HISTORIC PRESERVATION BOARD MEETING
CITY OF ST. PETE BEACH

Thursday, October 5, 2023
2:30 PM

PLANNING & ZONING DIVISION
STAFF FINDINGS REPORT
TO THE
HISTORIC PRESERVATION BOARD

Design Review Case No. 23077
Property Owner: Matthew Stephen Foster
Meeting Date: October 5, 2023
Prepared By: Brandon Berry, Planner, Planning and Zoning Division

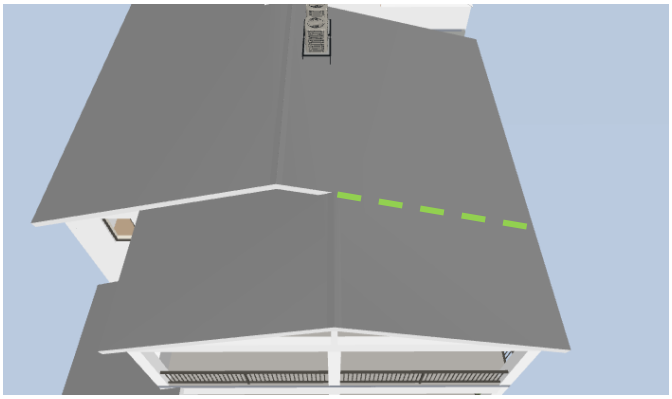
Staff did not find the structure to have a distinct secondary mass. This is due in part to the roofline lacking a full break and thus the northern side of the roof melding visually with the remainder, creating a "box-like" effect (see below). While the city's code is not prescriptive to require a porch or stoop at the frontage, they are provided as options to designers as a straightforward secondary mass that promotes visual interest at the front of the building and provides relief from what otherwise may be an unvaried primary mass. Staff recommends the designer provide a full break in the roofline that is evident from the sidewalk to provide visual interest at the frontage, or propose an alternative secondary frontage.

Above, left: Staff finds the front of the structure currently lacks a defined secondary mass, although there is potential for the balcony portion to be further visually detached from the primary frontage. Providing a full break in the roofline of the balcony portion may alleviate this issue.

1) The applicant shall demonstrate, either through an amended design or annotated plans, consistency with the following required design elements:
    a. Defined secondary frontage;
